Project Name: Coushatta Education Building

Project Number: 24.0002607.000

This Addendum 6 becomes as fully a part of the first issued documents as if originally issued therewith or originally contained herein.

1 C1.01 CIVIL EXISTING CONDITIONS& DEMOLITION PLAN
1" = 50'-0"

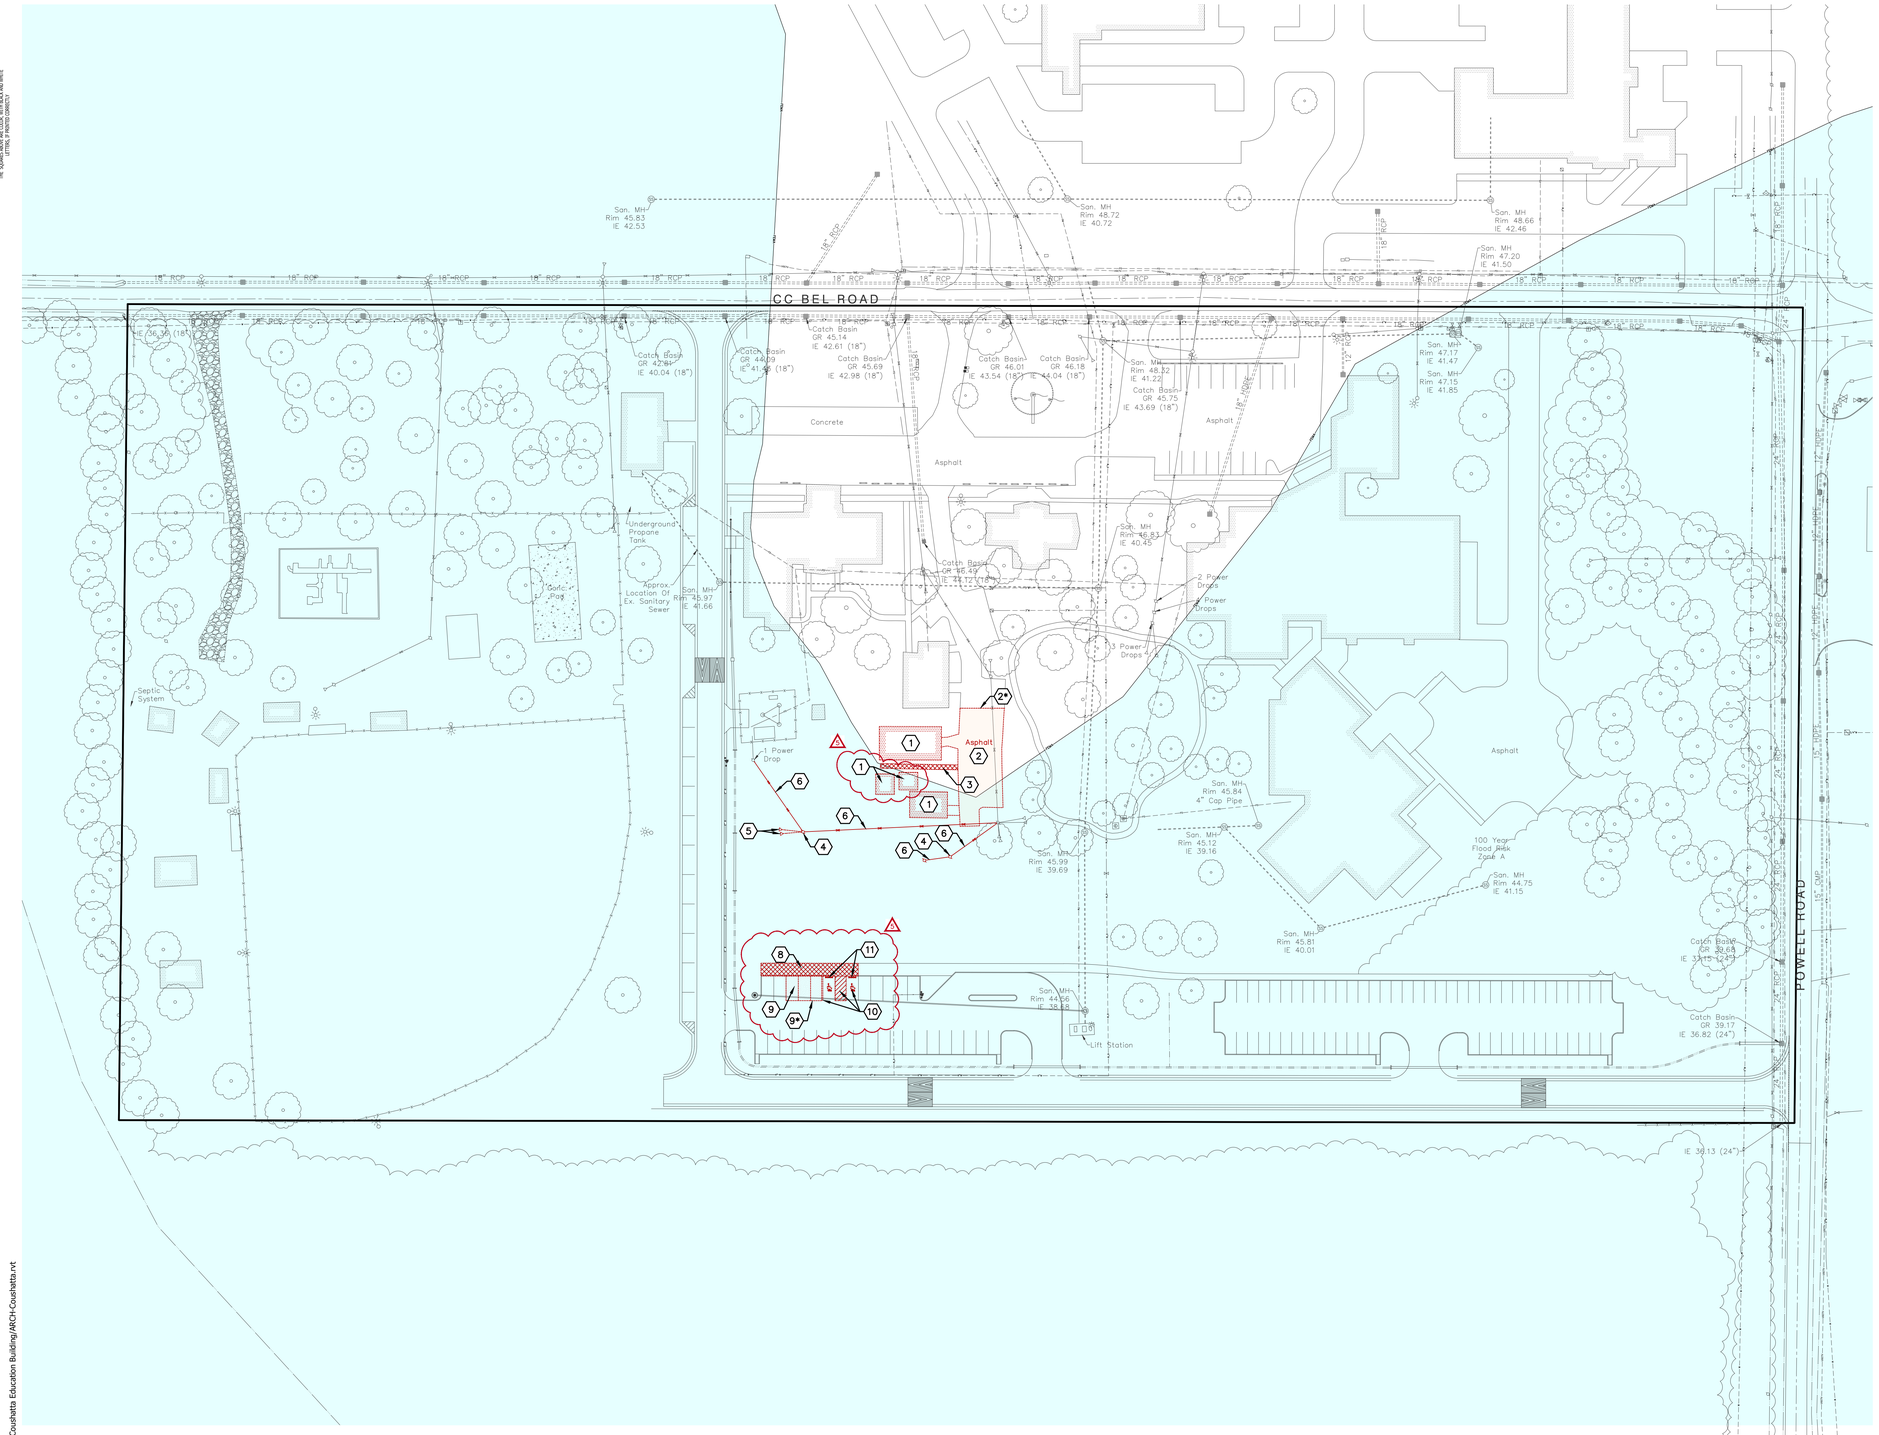
Sheet C1.01 – Existing Conditions & Demolition Plan

1. Update keynote #7 to be Not Used.
2. Update the amount of existing asphalt to be demolished at Keynote 2 and See asterisked 2 note for saw cut line.
3. Update to include asterisked keynote 3 for saw cut line.

1 C2.01 CIVIL LAYOUT PLAN
1" = 20'-0"

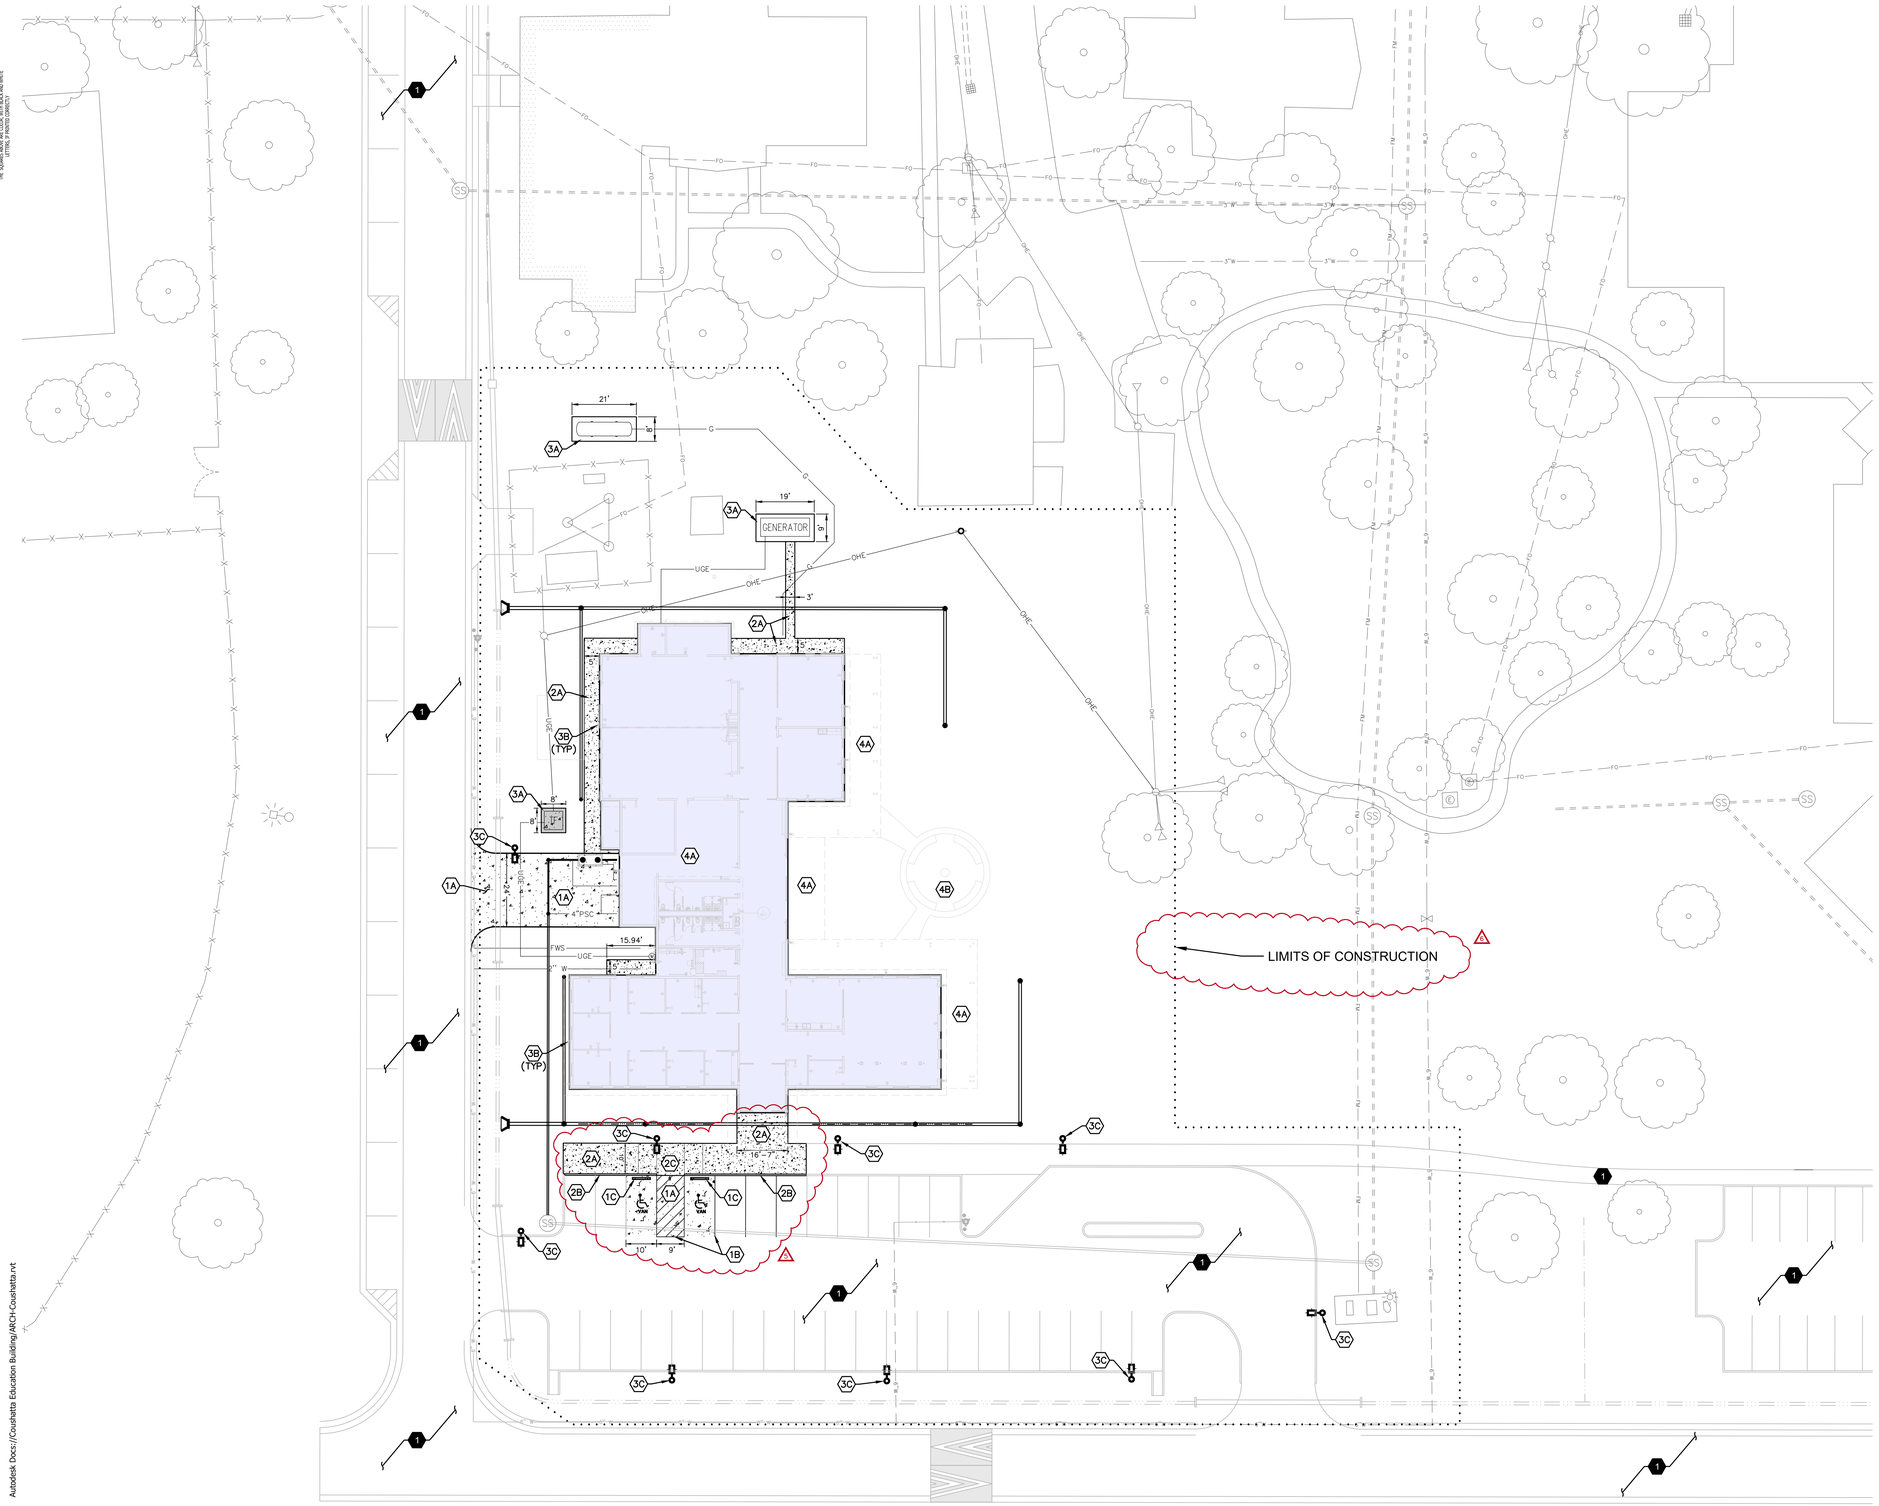
Sheet C2.01 – Layout Plan

1. Update 1/C2.01 plan to include dashed line and plan note indicating Limits of Construction.

1 E100 SITE PLAN - ELECTRICAL
1/16" = 1'-0"

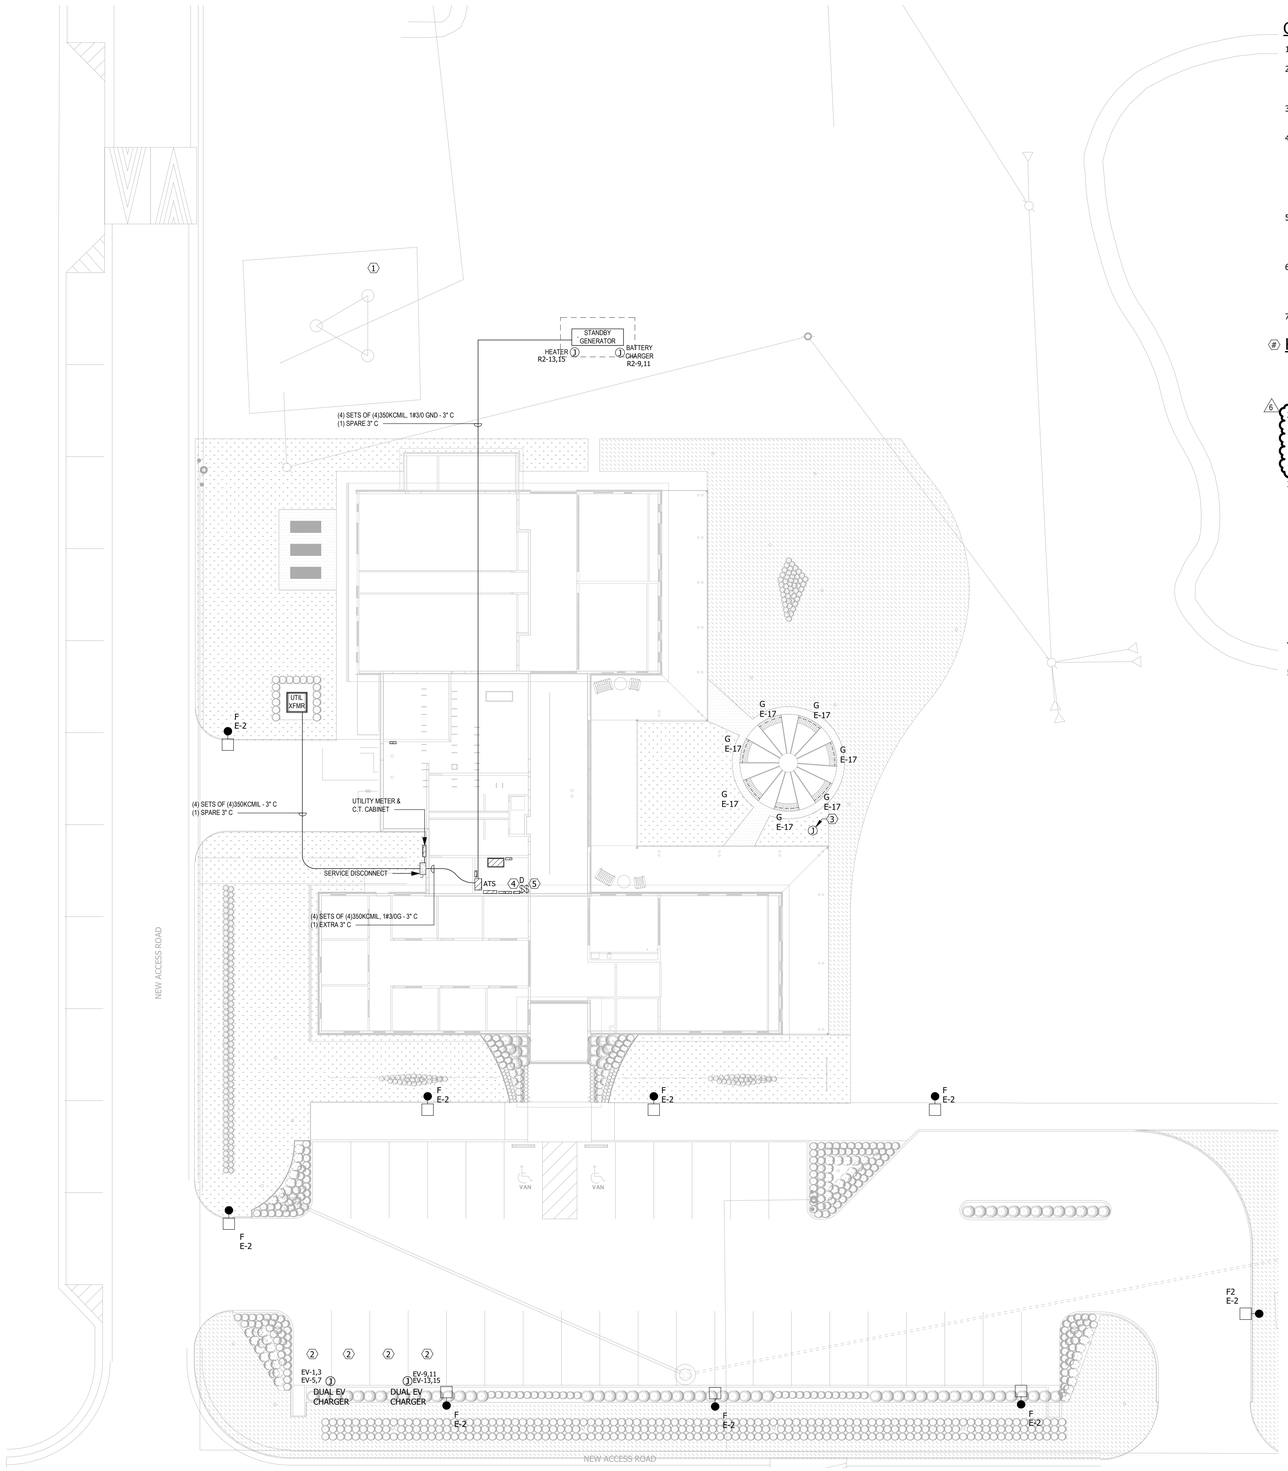
E100 – Site Plan Electrical

1. See updated keynote #2 which includes EV Charger make and model language from previous Addendum issuance.

2. ELECTRIC VEHICLE CHARGING SPACES. PROVIDE (2) LEVEL 2 DUAL CHARGERS AS SHOWN ON PLAN. EV CHARGER BRAND AND MODEL TO BE CHARGEPOINT CP6021X-80A-L7. IN ADDITION TO POWER CONDUIT, PROVIDE (1) 1" DATA CONDUIT PER CHARGER. THIS WILL BE A UNIT PRICE ITEM: PROVIDE A COST PER LINEAR FOOT FOR TRENCHING AS WELL AS A UNIT PRICE FOR THE EV CHARGERS THEMSELVES. 6

2 E700 ONE-LINE RISER DIAGRAM
NOT TO SCALE

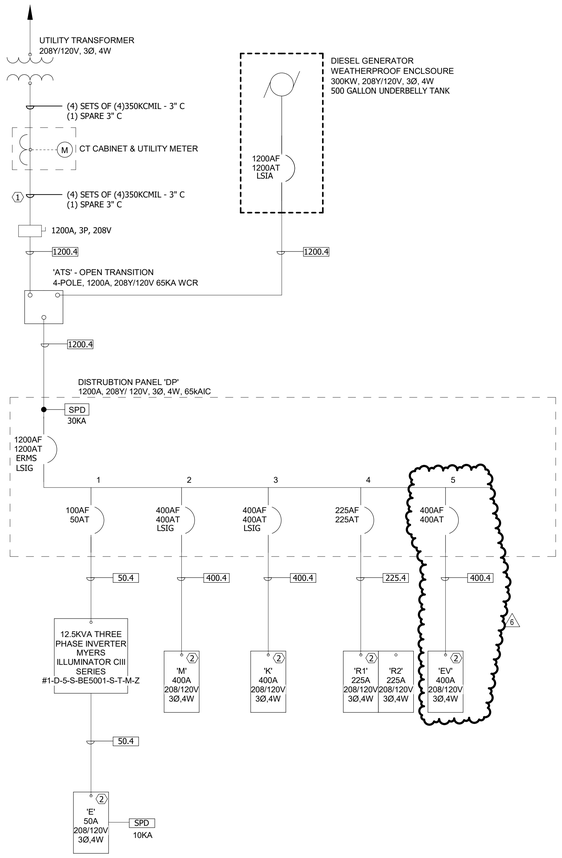
E700 – One-Line Riser Diagram

1. Update 2/E700 One-Line Riser Diagram EV information as indicated.
